CRITICAL MEASURE BCA COMPLIANCE ASSESSMENT

To:	Hi Noon Ski Club Thredbo	Date:	7 January 2025
Attention:	Ziggi Krpan	Project Ref:	3430
From:	James Alexander	Revision:	Rev D FINAL
Project:	Hi Noon Ski Club Thredbo		
Purpose:	BCA Compliance Assessment of proposed upgrades to sanitary compartment and conversion of existing storage room to SOU

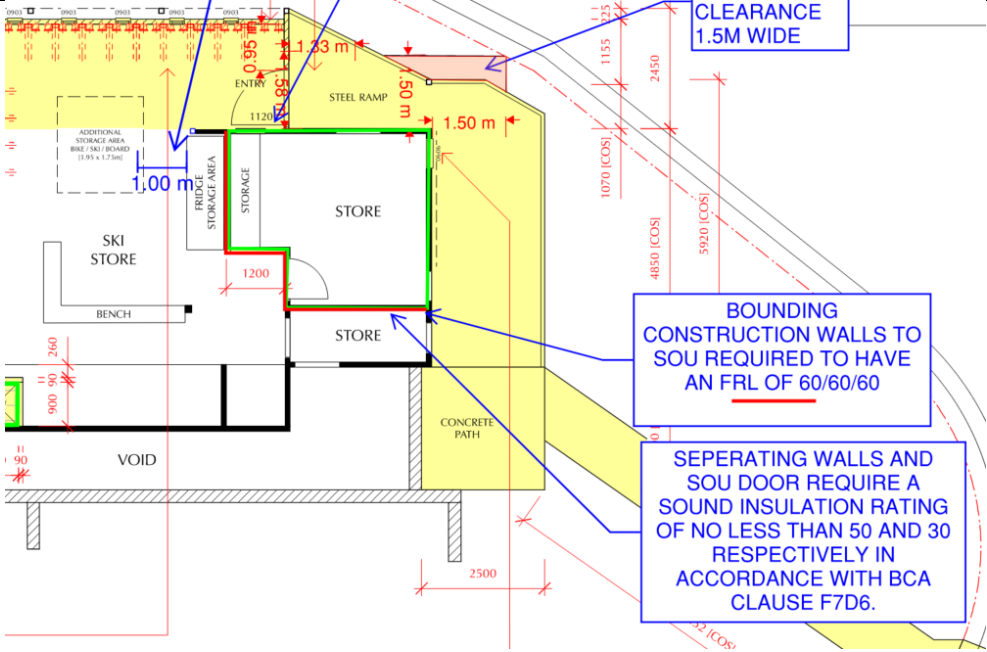
BCA CLAUSE D3D9 - ENCLOSURE OF SPACE UNDER STAIRS	<p>The subject sanitary compartment is located under the main internal stair and is provided with a door and hence is an enclosed space under a required stair. The enclosing walls are therefore required to be protected by fire rated linings achieving FRL 60/60/60 and a door achieving -/60/30.</p>	<p>It was noted that the walls were lined with 16 thick fire rated plasterboard which would likely achieve the required FRL.</p> <p>The proposed shower area increase is also to incorporate 16mm thick FRPB prior to linings with CFC and tiles.</p> <p>The door to sanitary compartment however was not a fire door. A fire door could be fitted, or a fire engineered performance solution developed to permit the existing solid core door.</p>

BCA CLAUSE	COMPLIANCE ISSUE	DESIGN RECOMMENDATION
	 <p>Figure 1 - Fire resisting requirements</p>	
<p>BCA CLAUSE D2D3 NUMBER OF EXITS</p> <p>BCA CLAUSE D2D5 - EXIT TRAVEL DISTANCES</p>	<p>In a building under 25m, one exit is required to be provided per level, the distance of travel to an exit or point of choice is required to be within 6m on the upper level and 20m on the ground floor level.</p>	<p>The sanitary compartment and proposed SOU are located within 20m of an exit.</p>
<p>BCA CLAUSE D2D7 - HEIGHTS OF EXITS, PATHS OF TRAVEL TO EXITS AND DOORWAYS</p> <p>BCA CLAUSE D2D8 WIDTH OF EXITS AND PATHS OF TRAVEL TO EXITS</p>	<p>In a required exit or path of travel to an exit —</p> <ul style="list-style-type: none"> • The unobstructed height throughout must be not less than 2m, except the unobstructed height of any doorway may be reduced to not less than 1980mm. • The unobstructed width of each exit or path of travel to an exit, except for doorways, must be not less than 1m. 	<p>The reduced height is located over the WC and therefore not considered a path of travel to an exit. The reduced ceiling height will however need to be addressed under F5D2.</p>  <p>Figure 2 - raked ceiling over WC is less than 2.1m over the WC.</p>
